Access Compliance Report

Public Rights-of-Way

Intersection ID: 11081	Main Street: WALNUT_AV	Cross Street: WESLEY_HEIGHTS_WY	Location:	N
ADA ID: 3FAAA918C764	Ramp Type: Perp	Initial Pass/Fail: Fail	Overall Compliance: No	Severity Score: 12.5

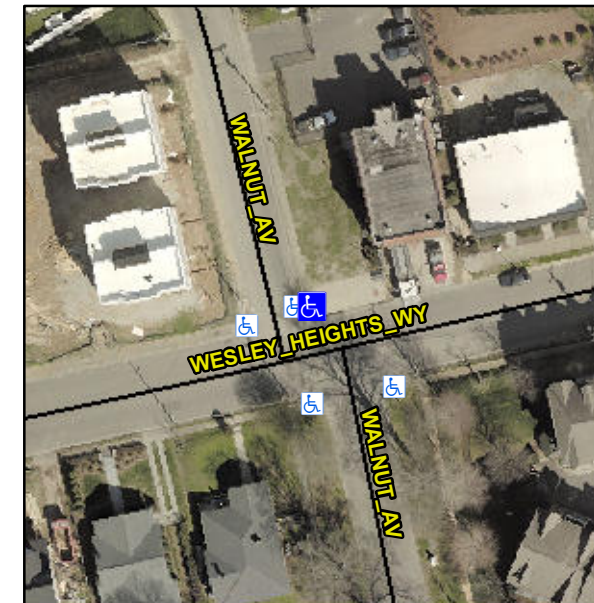
R304.2.2

Compliance	Description	Data	Compliance	Description	Data
N/A	Ramp Length (in)	103.0	No	Ramp Slope (%)	8.5
Yes	Ramp Width (in)	58.0	Yes	Ramp XSlope (%)	0.4
N/A	Flare Type LT	N/A	N/A	Flare Type RT	N/A
N/A	Flare Slope LT (%)	N/A	N/A	Flare Slope RT (%)	N/A
N/A	Flare Traversable LT?	N/A	N/A	Flare Traversable RT?	N/A
N/A	Landing Length (in)	N/A	N/A	DWS Provided?	N/A
N/A	Landing Width (in)	N/A	N/A	DWS Contrast?	N/A
N/A	Landing Slope (%)	N/A	N/A	DWS Length (in)	N/A
N/A	Landing X Slope (%)	N/A	N/A	DWS Full Width?	N/A
N/A	Landing Curb? (Y/N)	N/A	N/A	DWS Offset (in)	N/A
N/A	Shared Landing?	N/A			
N/A	Gutter Ponding?	N/A	N/A	Gutter Slope (%)	N/A
N/A	Gutter Lip Ht (in)	N/A	N/A	Gutter X Slope (%)	N/A
N/A	Painted X Walk1?	No	N/A	Painted X Walk2?	N/A
	X Walk 1 Direction	To SE		X Walk 2 Direction	N/A
N/A	X Walk 1 Width (in)	N/A	N/A	X Walk 2 Width (in)	N/A
	X Walk 1 Slope (%)	3.0		X Walk 2 Slope (%)	N/A
	X Walk 1 X Slope (%)	0.1		X Walk 2 X Slope (%)	N/A

Remove & Replace Entire Ramp.
